STAFF RECOMMENDATION
247 Cherokee Road
October 21, 2015

Application: New construction—addition, Partial demolition
District: Cherokee Park Neighborhood Conservation Zoning Overlay
Council District: 24
Map and Parcel Number: 10312000600
Applicant: Nancy Hayden
Project Lead: Paul Hoffman, paul.hoffman@nashville.gov

<p>Description of Project: New construction of a rear addition.</p> <p>Recommendation Summary: Staff recommends approval with the conditions:</p> <ol style="list-style-type: none">1. Staff approve the final details, dimensions and materials of windows and doors prior to purchase and installation; and,2. Staff approve the roof color and masonry materials for color, dimensions and texture. <p>Staff finds the application meets the design guidelines for the Cherokee Park Neighborhood Conservation Zoning Overlay.</p>	<p>Attachments A: Photographs B: Site Plan C: Elevations</p>
--	--

Figure 1. Existing house at 247 Cherokee Road

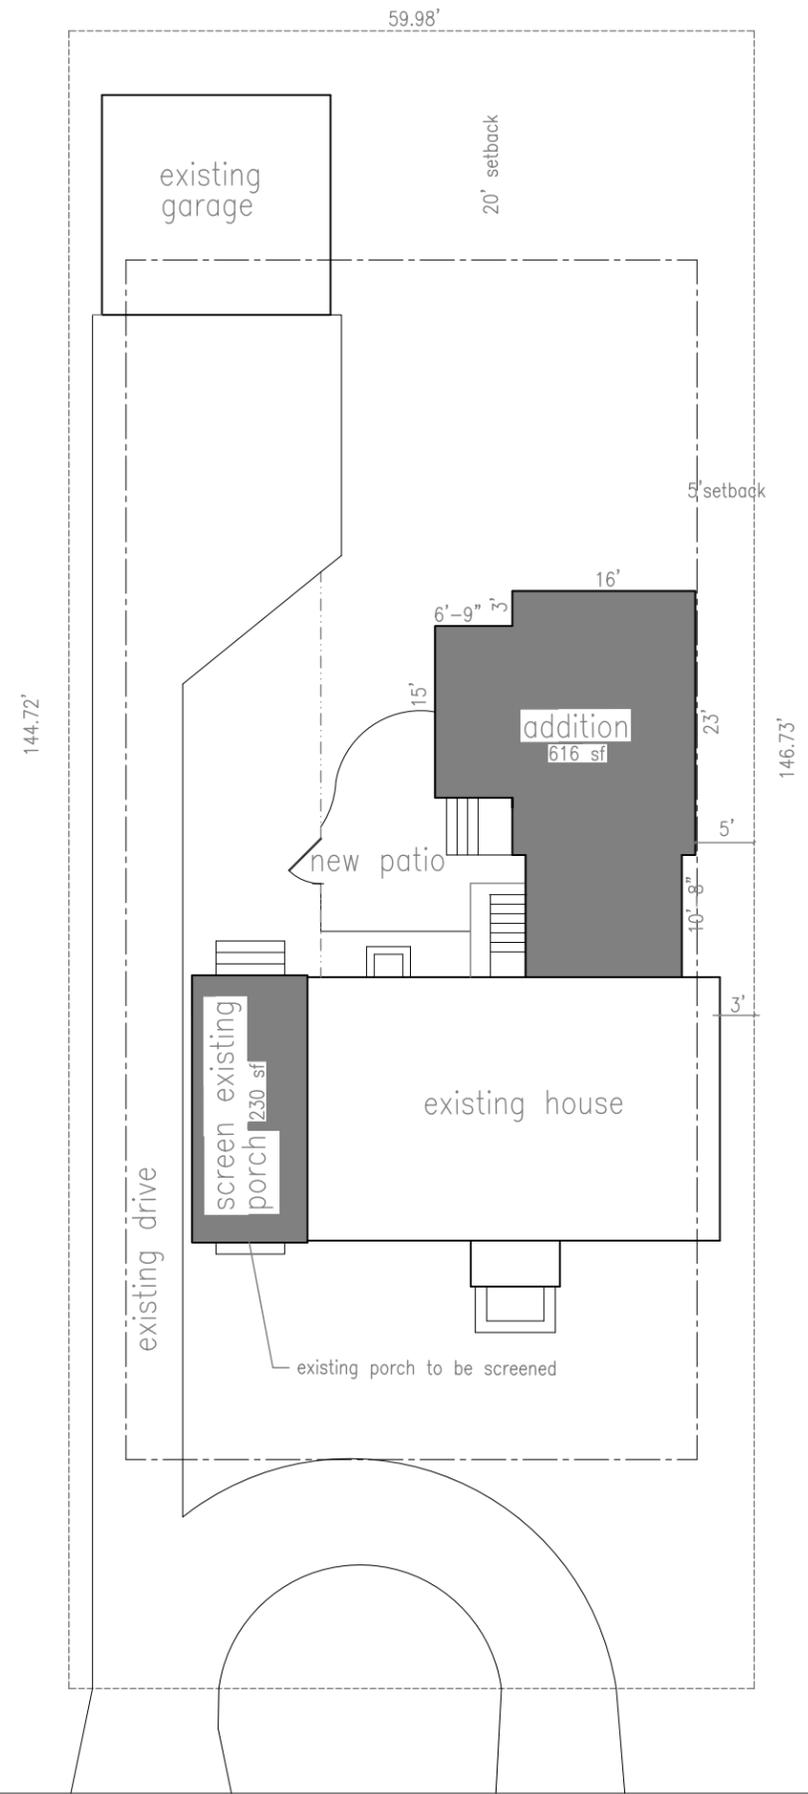
Background: 247 Cherokee Road is a contributing home in the Cherokee Park district, built circa 1933.

nha # 15018
A1.1

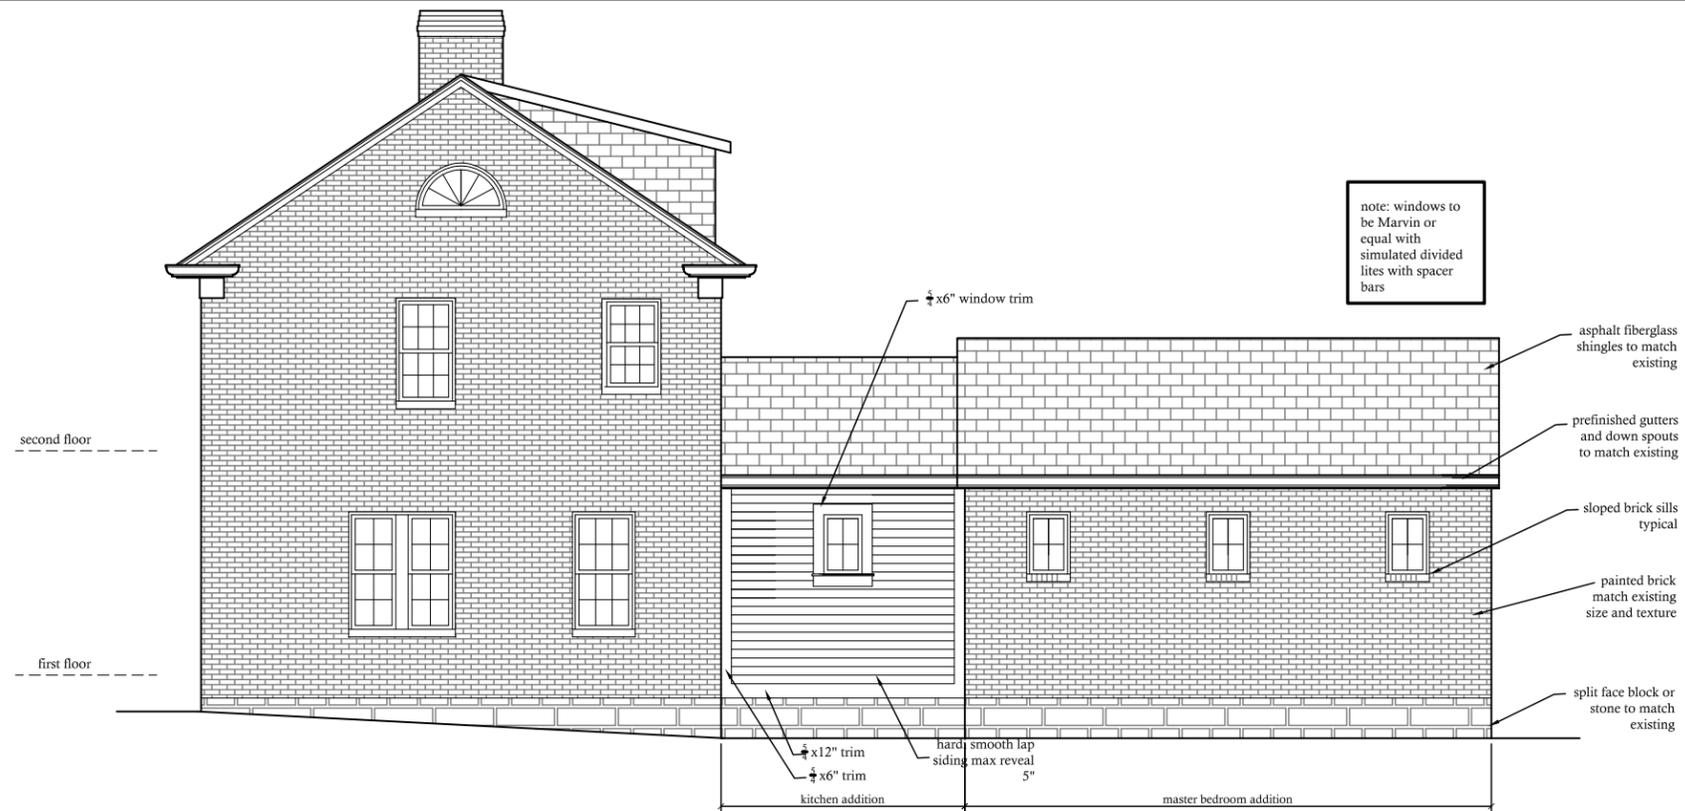
Height & Scale: The addition will inset two feet and six inches (2'6") feet from the existing house on the right side, and approximately twenty-eight feet (28') on the left. Its total width will be twenty-two feet, nine inches (22'9"). The total footprint will be six

hundred and sixteen square feet (616 sq. ft.) compared to the one thousand, one hundred and four square feet (1104 sq. ft.) of the historic home. The foundation height will match the existing. The eave height will be ten feet (10'), which matches the eave height of the existing side porch. The project meets section II.B.1.a. and b.

Design: The addition will be distinguished from the historic building with a change from brick to siding, and with the inset on each side. To the rear of the kitchen, the addition will have a similar design to the house, with brick cladding. The project meets section II.B.2.a and f.

Setback: The addition will be five feet (5') from the property line on the right side, and thirty-two feet (32') on the left. The rear setback will be forty-eight feet (48'). The project meets base zoning for setbacks and meets section II.B.1.c.

1. Staff approve the final details, dimensions and materials of windows and doors prior to purchase and installation; and,
2. Staff approve the roof color and masonry color, dimensions and texture.
